Access Compliance Report Public Rights-of-Way (Curb Ramps)

Main Street: BULLARD_RD Cross Street: BULLARD_RD Location: NW

ADA ID: RPAT211011133511 Ramp Type: Type 3 - Combination 1 Initial Pass/Fail: Fail Overall Compliance: No Severity Score: 15

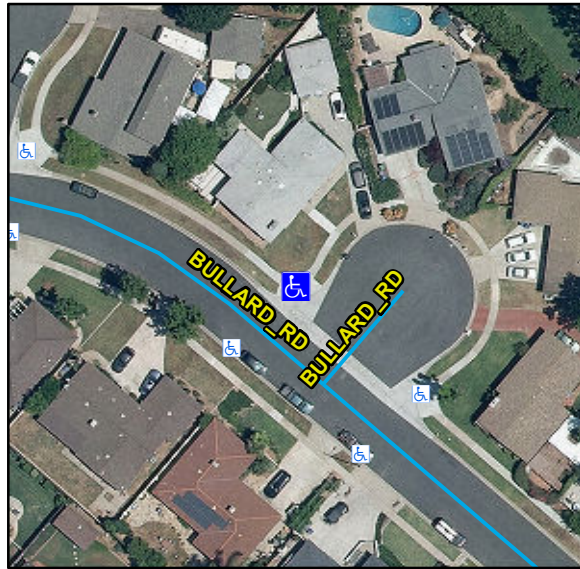
Compliance	Description	Data	Compliance	Description	Data
N/A	Ramp Length LT (in)	80	N/A	Ramp Length RT (in)	73
Yes	Ramp Width LT (in)	49	Yes	Ramp Width RT (in)	51
Yes	Ramp Run Slope LT (%)	1	Yes	Ramp Run Slope RT (%)	7.9
No	Ramp Cross Slope LT (%)	2.7	Yes	Ramp Cross Slope RT (%)	0.4
N/A	Ramp Length (in)	77	N/A	Flare Type LT	
Yes	Ramp Width (in)	48			N/A
No	Ramp Run Slope (%)	8.5	N/A	Flare Slope LT (%)	N/A
Yes	Ramp Cross Slope (%)	1.9	N/A	Flare Traversable LT	N/A
N/A	Landing Present	N/A	N/A	Flare Type RT	
N/A	Landing Length (in)	N/A			N/A
N/A	Landing Width (in)	N/A	N/A	Flare Slope RT (%)	N/A
N/A	Landing Run Slope (%)	N/A	N/A	Flare Traversable RT	N/A
N/A	Landing Cross Slope (%)	N/A	N/A	DWS Provided	N/A
N/A	Landing Movement Obstructed?	N/A	N/A	DWS Contrast	N/A
	Landing Movement Type	N/A	N/A	DWS Length (in)	N/A
N/A	Landing Shared	N/A	N/A	DWS Full Width	N/A
N/A	Clear Space	Yes		DWS Offset Type	N/A
N/A	Clear Space To Crosswalk (in)	N/A	N/A	DWS Offset Left (in)	N/A

Remove & Replace Curb Ramp With Two New Directional Ramps or Equivalent.
